Subject: U-2579 D, E,& F Request for Modification to Individual Section 404 and Section 401 Water Quality Certification

Subject: **Request for Modification to Individual Section 404 and Section 401 Water Quality Certification** for the Winston-Salem Northern Beltway from US 52 to US 311 (New Walkertown Road), Forsyth County. Federal Aid Project No. NHP-0074(213), TIP Nos. U-2579D, E& F. Division 9.

Permit Impact Site Modifications

SITE 5

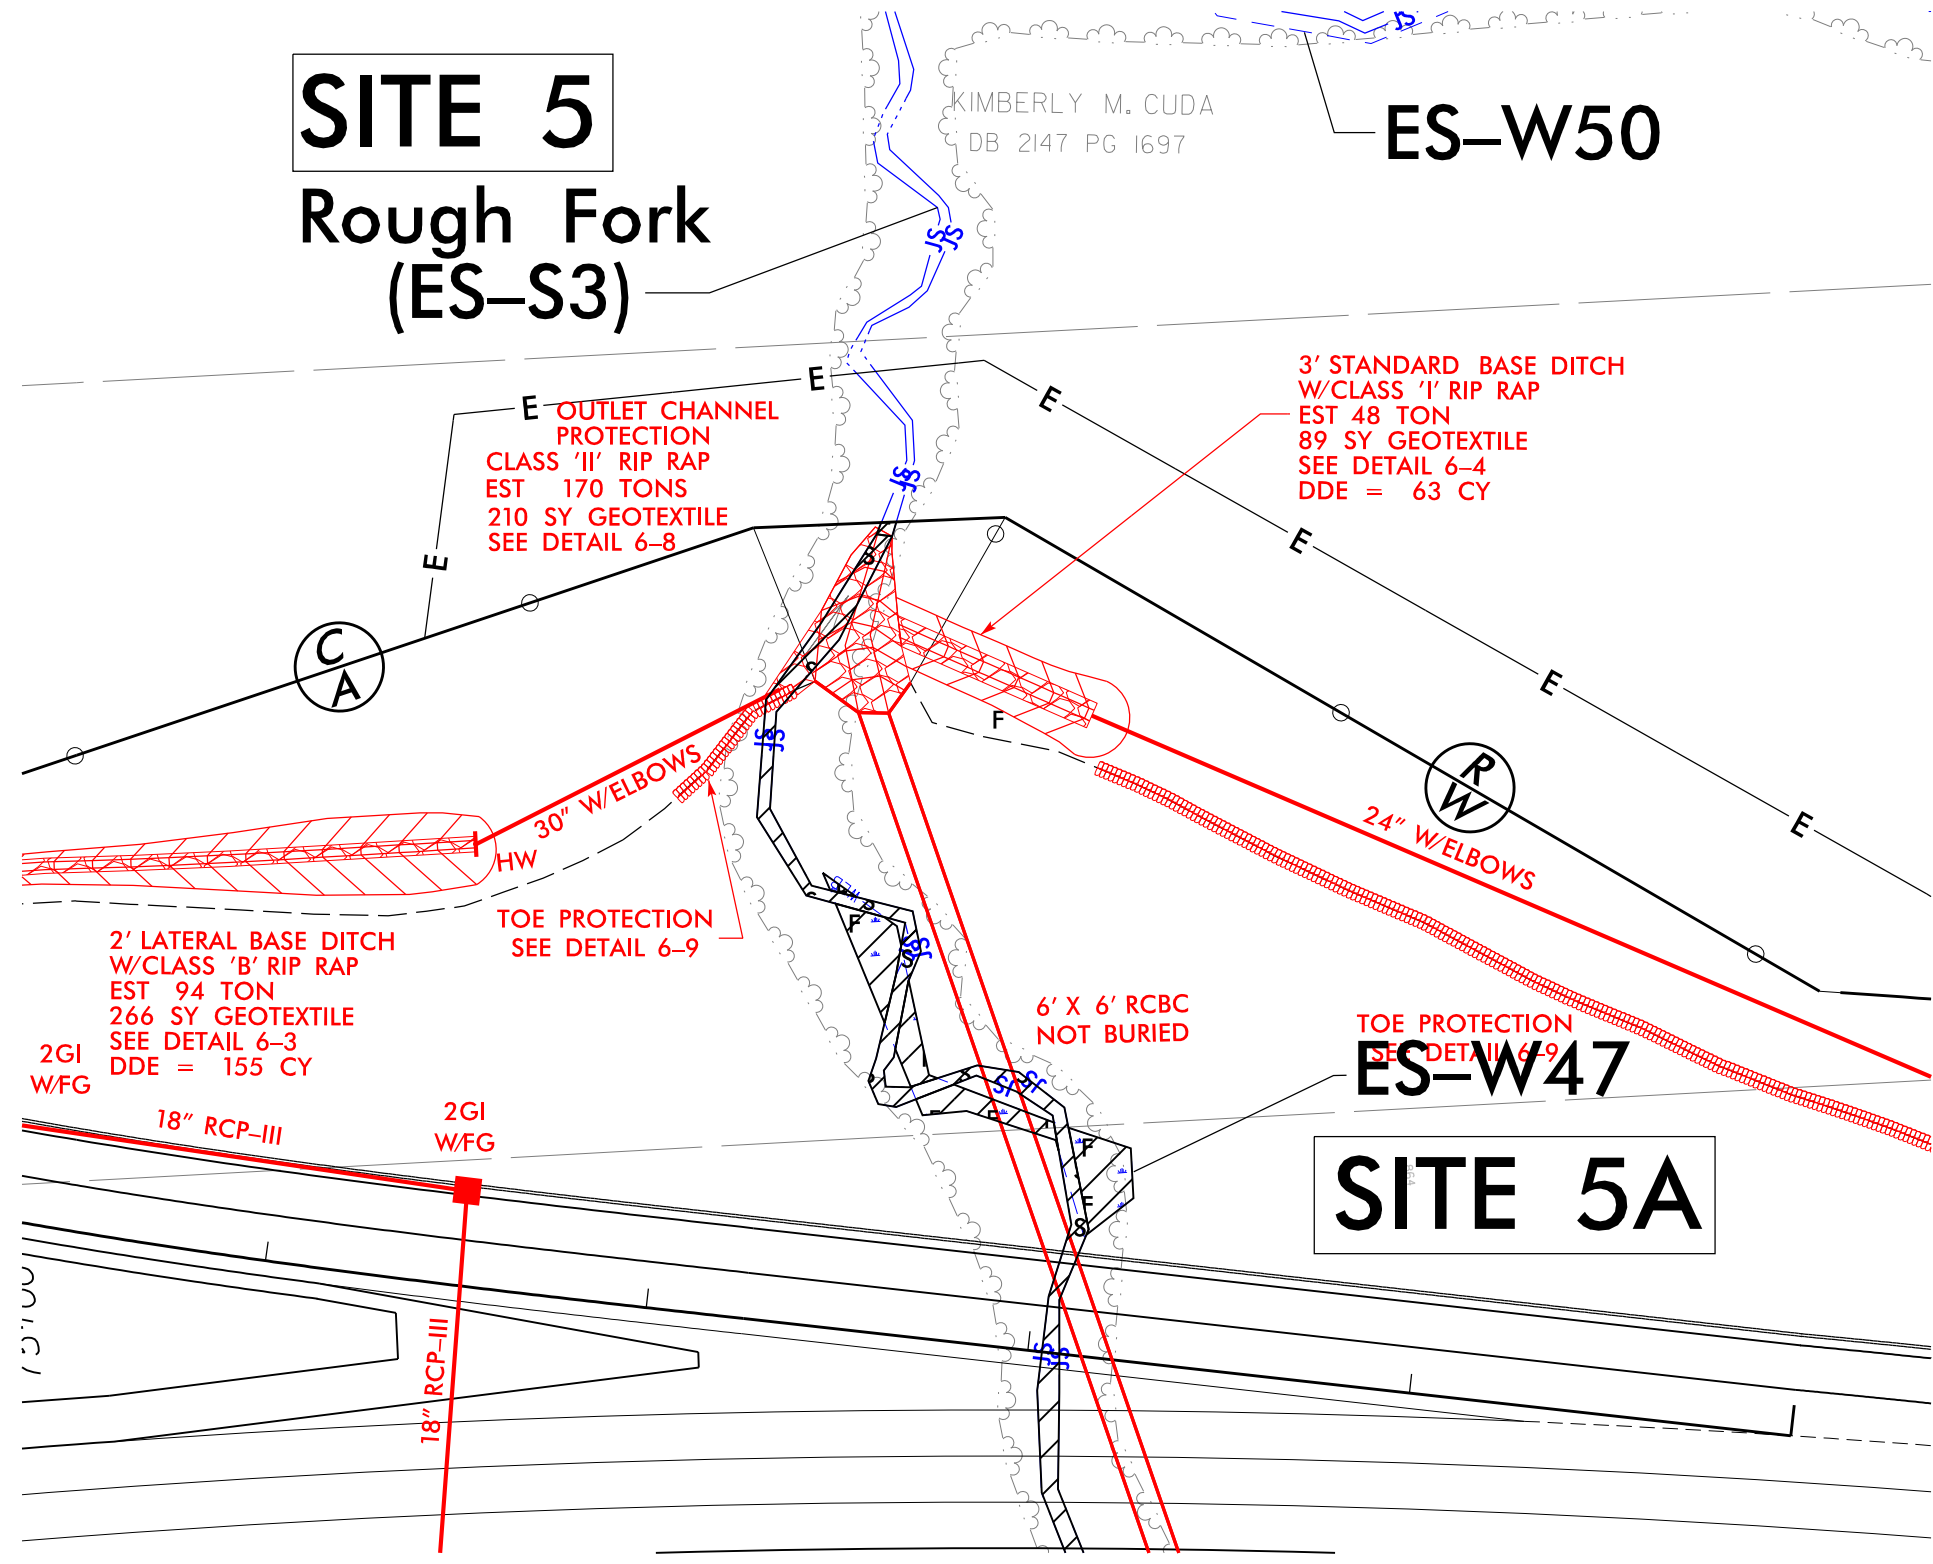
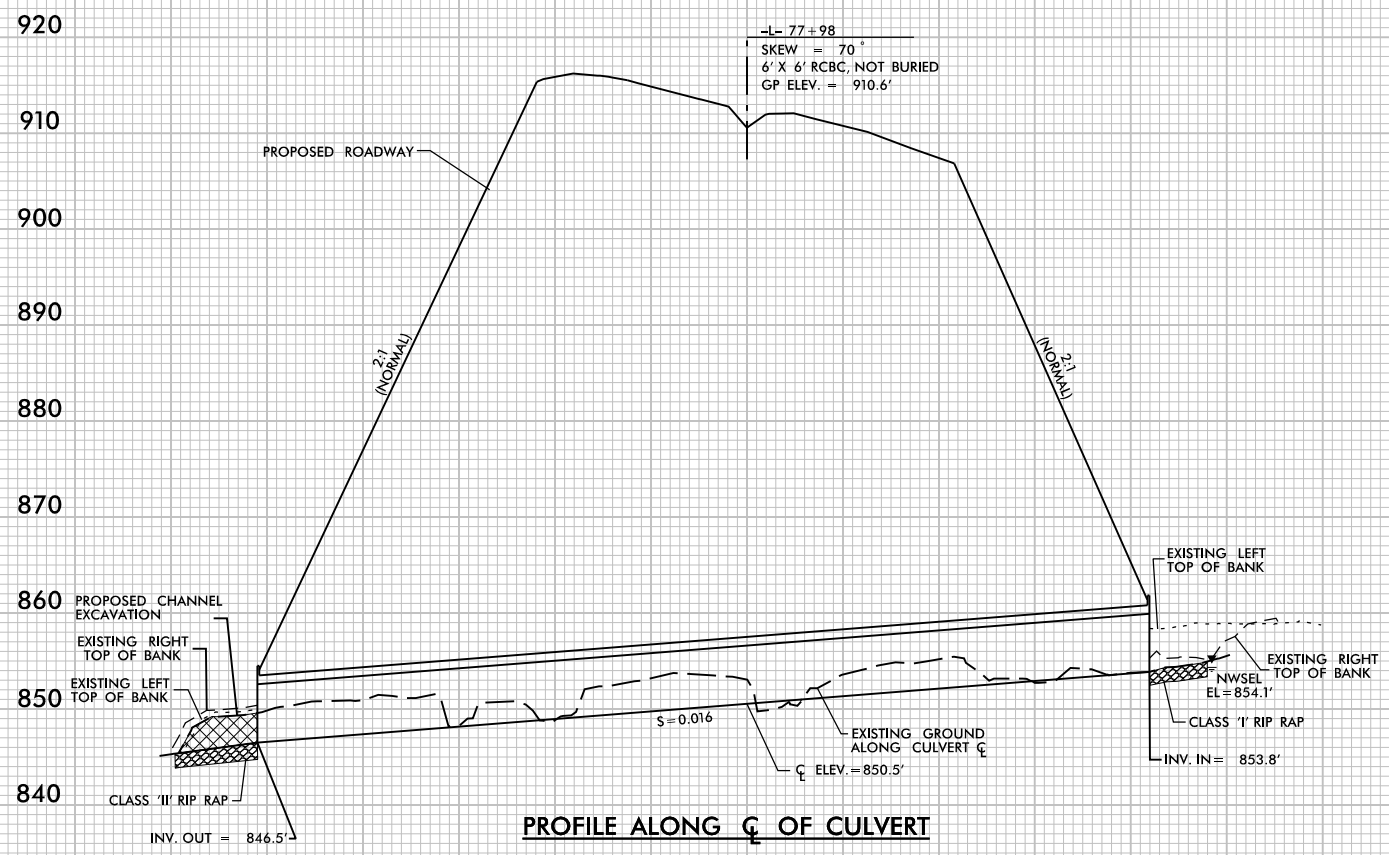
This permit modification package also includes revised drawings for Permit Impact Sites 5, 7, 13, 15, 17, 19, and 27. These sites have changed slightly due to the final culvert design as illustrated on the attached plan sheets; however, the impacts at these sites did not change from the previous modification referenced above. The culvert length increased by no more than 5 feet and decreased in length by no more than 20 feet at an individual site. The slight changes in length were captured in the previous plans as permanent impacts due to the inlet or outlet channel protection. The attached plans sheets have been provided to replace the previous plan sheets.
